## DART SERVICE INSTRUCTION

TO AMEND INSTALLATION INSTRUCTIONS D206-559 REV. K OR EARLIER AND INSTRUCTIONS FOR CONTINUED AIRWORTHINESS ICA-D206-559 REV. 2 OR EARLIER REF. TCCA STC: SH92-17

Α	NEW IS	SSUE	CP	10.06.30		
REV.		C	ESCRIPTION	BY	DATE	
DESIGN		P	DART AEROSPACE LTD			
DRAWN		P	HAWKESBURY, ONTAR	IO, CAN	ADA	
CHECKED		<u></u>	DRAWING NO.		REV. A	
MFG. APPR.		, N/A	DSI 9527	5	SHEET 1 OF 2	
APPROVED		1111	TITLE		SCALE	
DE APPR.			BOLT CHANGE	NTS		
DATE	10.0	6.30	COPYRIGHT © 2010 BY DART A THIS DOCUMENT IS PRIVATE AND CONFIDENTIAL AND IS SUPPLIED NOT TO BE USED FOR ANY PURPOSE OR COPIED OR COMMUNIC WRITTER PERMISSION FROM DART AE	O ON THE EXPRE	SS CONDITION THAT IT IS

FIGURE 4: TYPICAL CLAMPING DETAIL (D206-559)
FIGURE 32-3: TYPICAL CLAMPING DETAIL (ICA-D206-559)

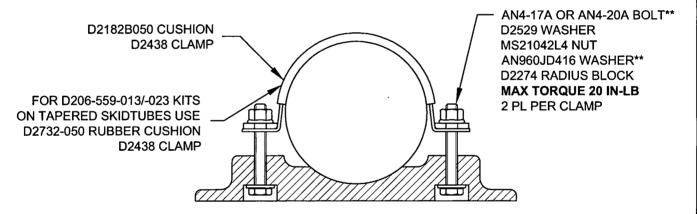
For D206-559-011/-013/-021/-023/-031/-033 bearpaw kits, the AN4 bolts specified were for installation with the aft skidtube wearshoe removed. Bolt lengths are increased to accommodate installation with the skidtube wearshoe installed, which is more practical.

Figure 4 of D206-559 and Figure 32-3 of ICA-D206-559 are amended as follows:

\*\*USE AN4-17A BOLTS WITH AN AN960JD416 (OR NAS1149D0463J) WASHER IF INSTALLING BEARPAW ON 3.0" DIA. TUBE OR SMALLER. USE AN4-20A BOLTS WITH TWO AN960JD416 WASHERS IF INSTALLING BEARPAW ON TUBE LARGER THAN 3.0" DIAMETER (DART TUBE). ADDITIONAL AN960JD416 WASHERS MAY BE ADDED UNDER NUT TO ENSURE 2-4 THREADS IN SAFETY. IT IS ALSO ACCEPTABLE TO USE LONGER/SHORTER AN4 BOLTS IF REQUIRED TO ENSURE BEARPAW IS HELD SECURELY.
